PREVOST

**WARRANTY
BULLETIN**

WB15-50

DATE :	DECEMBER 2015	SECTION :	18 - BODY
EXPIRATION:	DECEMBER 2017		
SUBJECT :	REAR JUNCTION BOX DECAL, R34 RELAY INFO

Fig.3 R34 Relay incorrect 12V information (X3-45 Coach Shown).

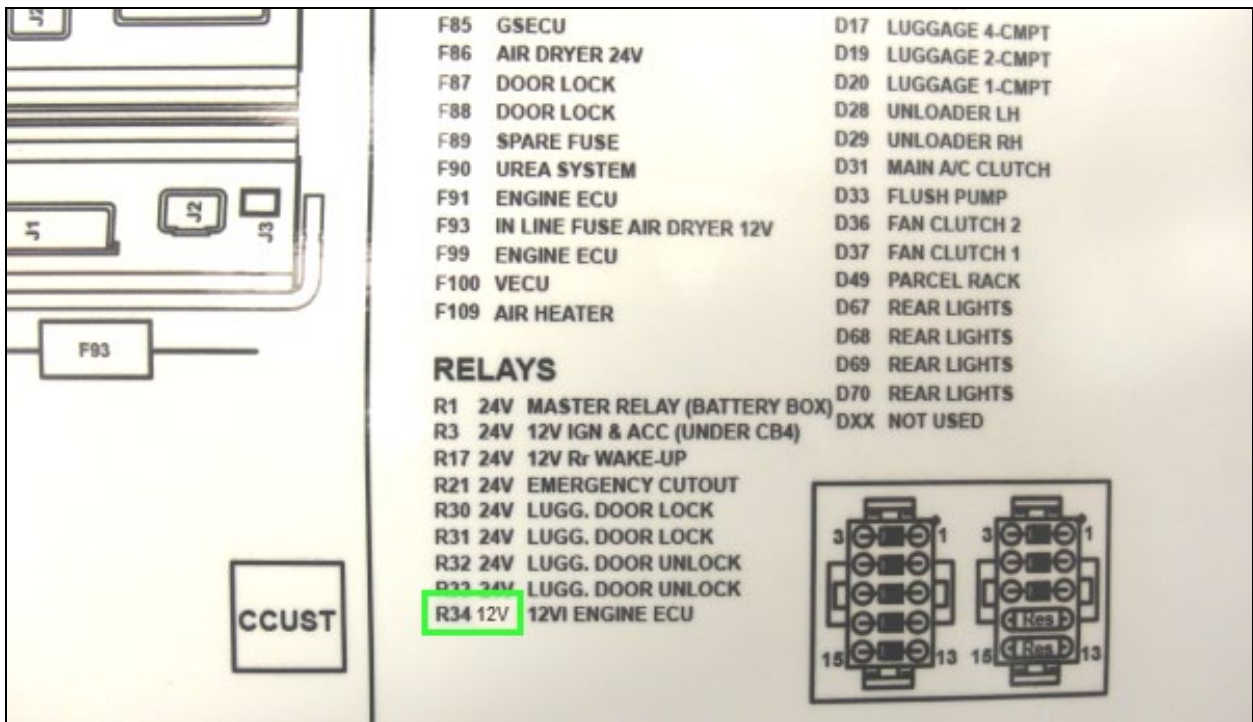
On the vehicles affected by this bulletin the rear junction box decal located in the right engine compartment is displaying incorrect information regarding the R34 relay voltage.

Specifically, the R34 relay should be identified as a 24 volt relay instead of a 12 volt relay.

2. On the decal lower right corner, validate that the R34 relay description is inaccurate (Fig.3) and identifies the relay as being a 12 volt relay (12V) instead of a 24 volt (24V).

Fig.5 Decal showing correct R34 voltage (X3 Coach Shown).

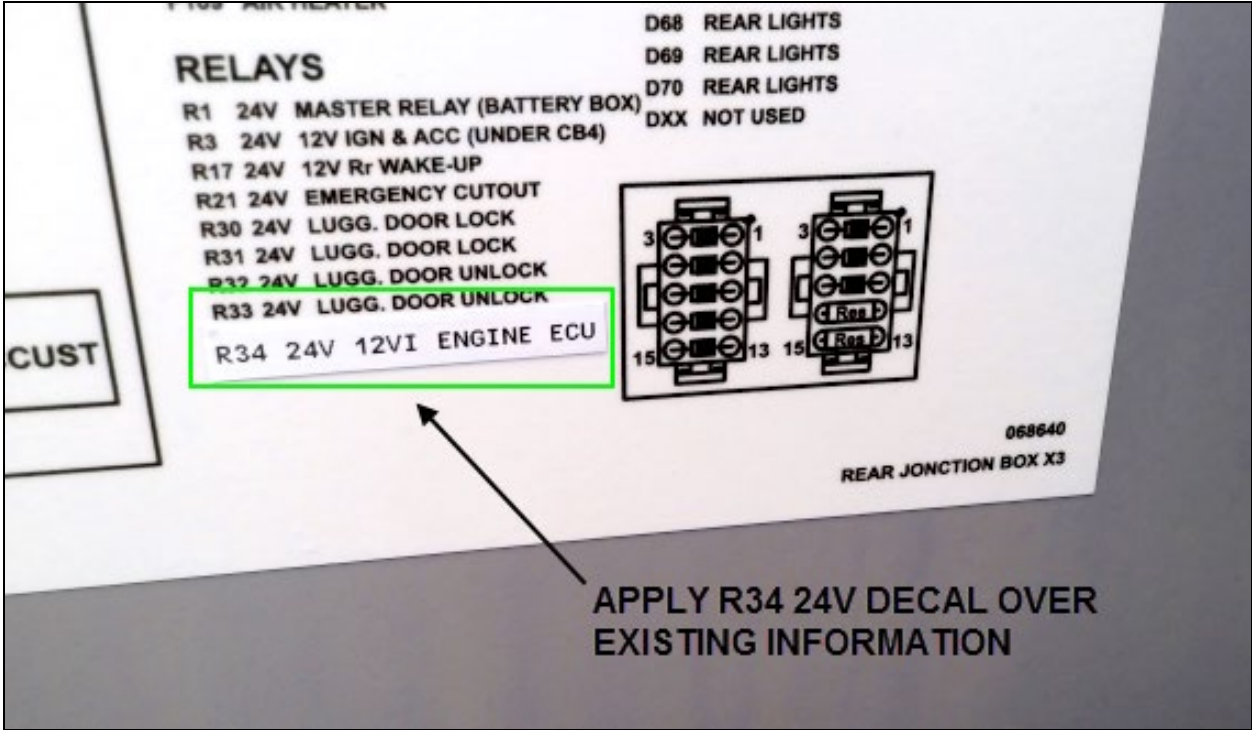
4. Apply the new decal over the existing 12 volt information as shown on Fig.5 and make sure of proper adhesion (apply pressure on the entire area with a plastic card or scraper. In cold weather, apply moderate heat as necessary).

Consequently, all affected vehicles must have a small decal displaying the correct information applied over the rear junction box decal R34 relay description.
